**In-Depth Design and
Maintenance Manual
for Vault Toilets**

Amendments for the In-Depth Design Manual For Vaults

The following changes should be made to the text:

Figure 2

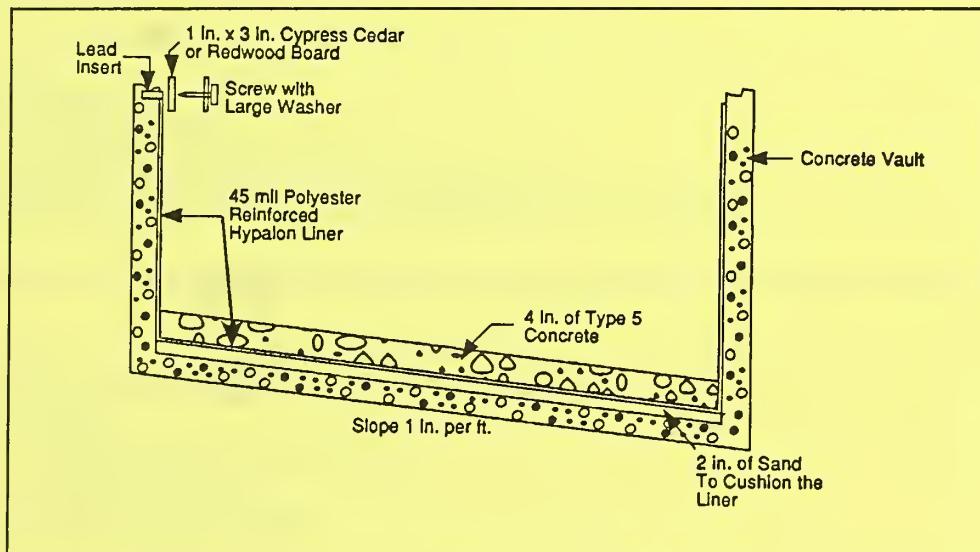
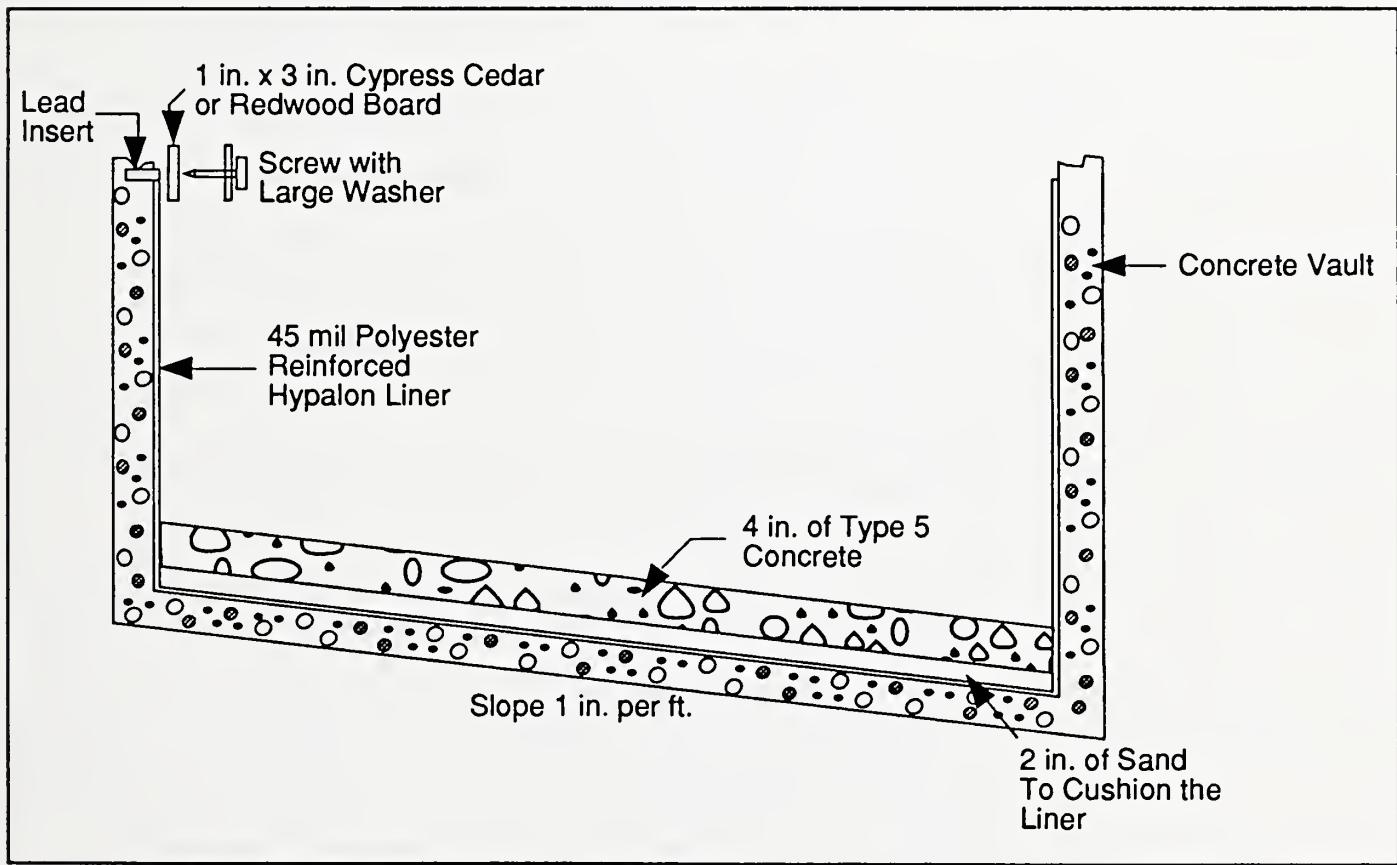
Figure 2 improperly illustrates the 2 inches of sand placed on top of the liner. The sand should be placed under the liner and then the 4 inches of type 5 concrete should be deposited directly on the liner.
